## ADVANCE CEM

Subject: Logic Change  
 IBM 729 NOR - Machines with JT 85180 V  
 (B/M's 8023445 and 8026561)  
 See Advance CEM dated August 11, 1964

Subject: Tape Drive Tester - Power Cable

SUBJECT : CORRECTIONS TO FIELD B/M 8026952 WTC CEM: 156 (-)

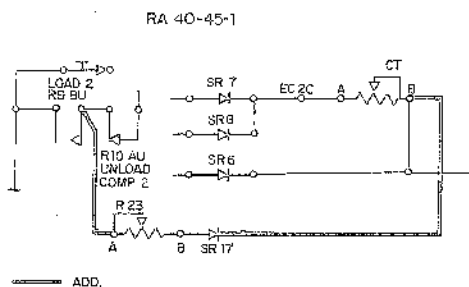
To avoid tape dumping during loading after a HS Rewind, potentiometer R23 (P/N 8018018) and diode SR 17 (P/N 315902) have been added.

This potentiometer must be adjusted so that at the end of the HS rewind, the tape is slightly to be flush with the nylon pulleys. Avoid a loop above the column. (To check it, disconnect the head bake up motor during the HS Rewind). Then, check by depressing the tape with one finger, in front of the slit guides; a light depression should turn the left reel.

### 56 (206) Tape Switching Signal Cable Routing IBM 729 II, IV, V, VI

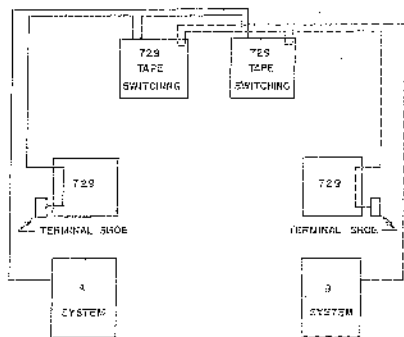
In some dual system installations with type switching, it may be necessary to drop power on one system and continue operating on the second system. Unless the Signal Cables are properly terminated, operation on one system is not possible if power is down on the other system.

The Signal Lines for each system must be terminated at a tape unit that has power on.

## 163 (-) Partial Brake Adjusting Tool P/N 8018462 IBM 729 All Models French Origin

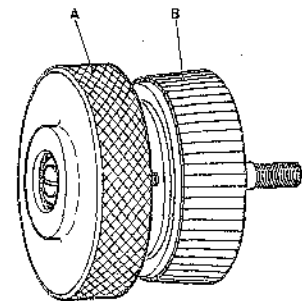
A new tool has been developed to perform the adjustment of the partial brake during HS Rewind (to prevent Tape Wrinkle).

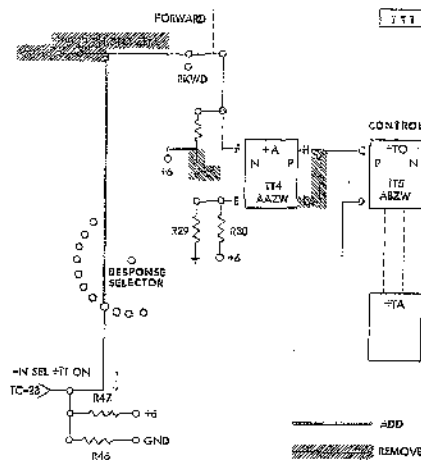
3. Remove wire from CE Connector # 18.

4. Pull wire back through cable facing until it will reach to pin # 4 of the top wafer of the response selector switch. Count pins counterclockwise from the common, but not including the common. Solder wire to pin # 4.

5. SMS Card locations TT1 to TT10 are counted left to right looking at the wiring side:

Remove  
yellow wire                      TT4-G to TT5-C

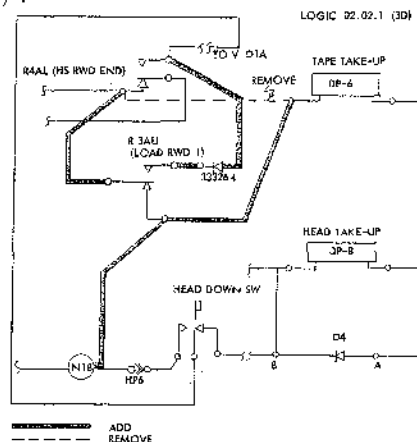
Remove wire from R4AL N/C to DP6 pick

Add wire from	R4AL N/C to R3AU op
	R3AU N/C to DP6 pick
	R3AU N/C to NEON 18 (wire to head down switch)
Add diode from	R4AL N/O (plate ) to R3AU N/O (cathode)

Use any available diode normally used in back circuit elimination or arc suppression, such as a top-hat, AM type or small, two-plate selenium type. If diodes are not available, order P/N 333264 on Field Requisition Card code 6 from COP Only.

The above circuit will be installed by ECR 45-229 on all machines leaving the plant, and subsequently will be picked up on EC 253520.

337 (-) Positioning of the Vacuum Switch Capacitors IBM 729 B II to VI (French origin)

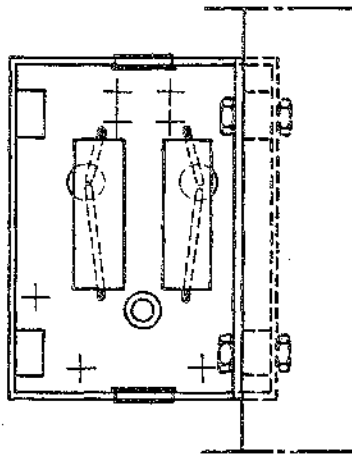
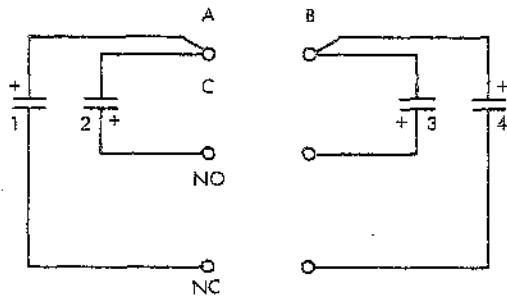
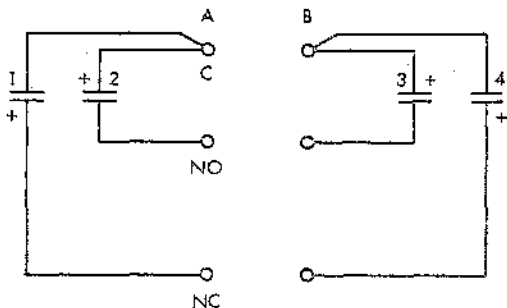
**SAFETY** A short hazard exists in the capacitors located outside the Vacuum Switches.

The wire or the body of the capacitor may be damaged by the outer sharp corner of the Vacuum column.

Note :  
1 and 4 : outer capacitors  
2 and 3 : inner capacitors

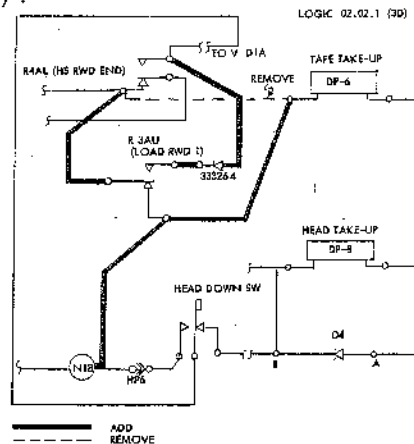
Remove wire from R4AL N/C to DP6 pick

Add wire from R4AL N/C to R3AU op  
 R3AU N/C to DP6 pick  
 R3AU N/C to NEON 18 (wire to head down switch)  
 Add diode from R4AL N/C (plate) to R3AU N/C (cathode)

Use any available diode normally used in back circuit elimination or arc suppression, such as a top-hat, AM type or small, two-plate selenium type. If diodes are not available, order P/N 333264 on Field Requisition Card code 6 from COP Only.

The above circuit will be installed by ECR 45-229 on all machines leaving the plant, and subsequently will be picked up on EC 253520.
